SUBJECT: Application for amends to Licenses NPF-10 & NPF-15,  
 clarifying requirements for determining content of inservice  
 insp tube sample by deleting tubes in batwing area based on  
 performance of corrective action program. Fee paid.

DESCRIPTION AND SAFETY ANALYSIS  
OF PROPOSED CHANGE NPF-10/15-240

This is a request to revise Technical Specification 3/4.4.4, "Steam Generators."

FIGURE 1 SONGS-2 STEAM GENERATOR ARRANGEMENT

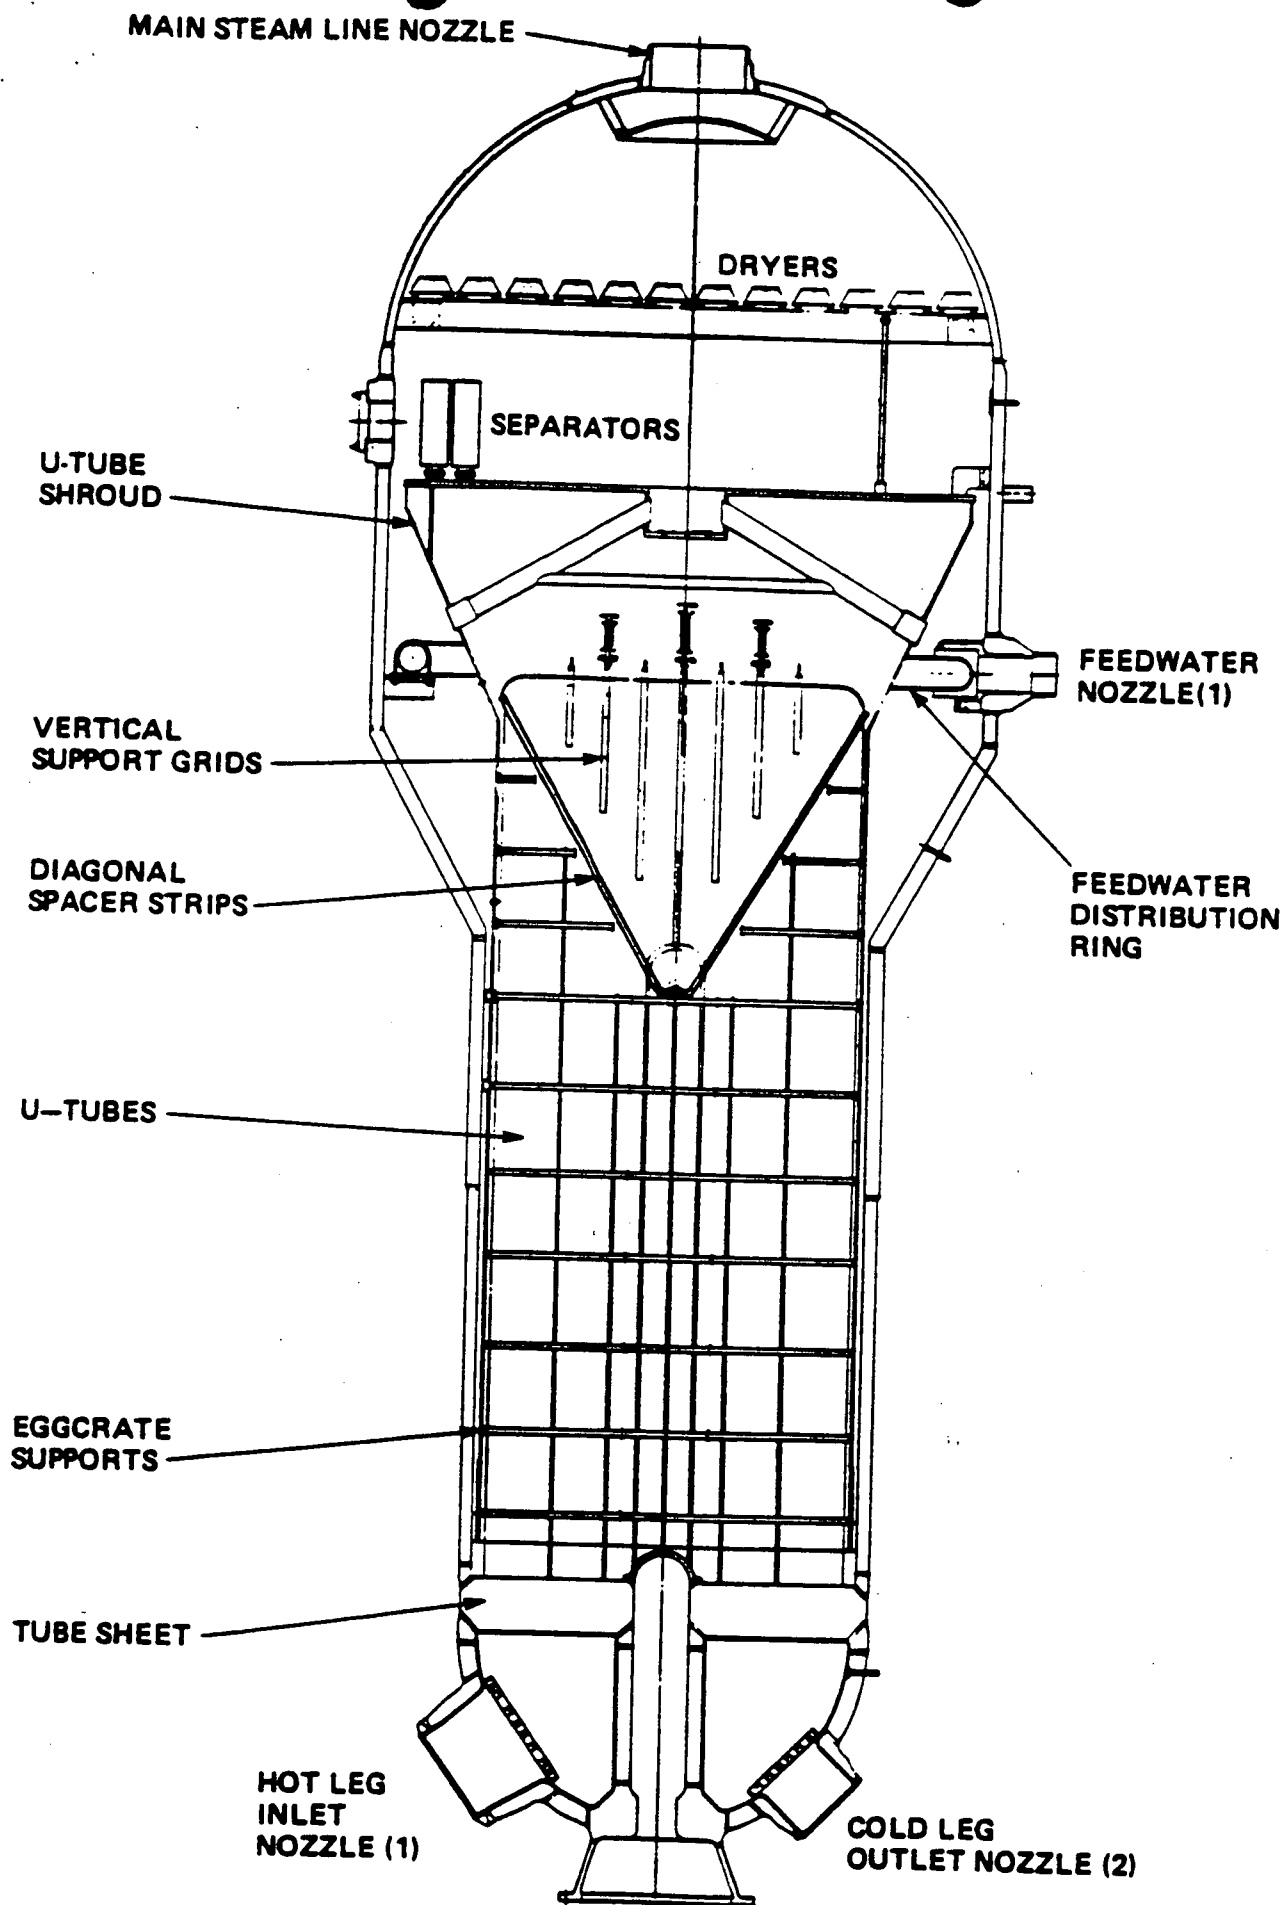
Each steam generator contains 9350 mill annealed inconel 600 tubes arrayed in a triangular pitch U bundle. These tubes are supported along their vertical lengths by seven full diameter eggcrate supports and three partial diameter eggcrate supports (see Figure 1). The bend and horizontal lengths of the tubes are supported by diagonal ("batwing") straps, which cross the tubes just below the start of the bend, and as many as seven vertical support straps, depending on the horizontal length of the tube (see Figure 2). The vertical straps are connected in the out-of-plane dimension by horizontal straps. A stay cylinder is installed at the central portion of the tubesheet to permit reduction of tubesheet thickness. The region above the stay cylinder cannot be tubed, and forms a hollow cavity at the center of the tube bundle.
